PRODUCT / PROCESS CHANGE NOTIFICATION

PCN-000710

Additional Source to Support Production Assembly and Final Test from Carsem Suzhou to Carsem Malaysia

PCN No. 000710
Qualification of Carsem Ipoh for TS3001X-M0XXQFNR products

Lead frame outline Comparison CARSEMSZ (OLD) Vs CARSEMIPH(NEW)

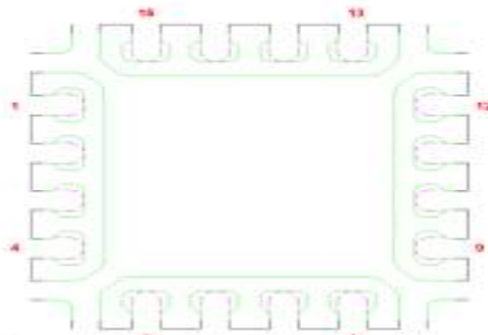
No Difference on lead frame outline for CARSEMSZ and CARSEMIPH as both are using the same lead frame.

**Bonding Layout (CarsemSZ vs
CarsemIPH)**

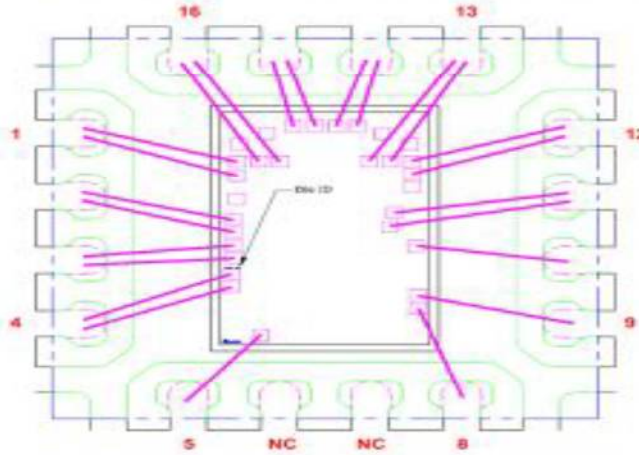
No Change in Bonding Layout.
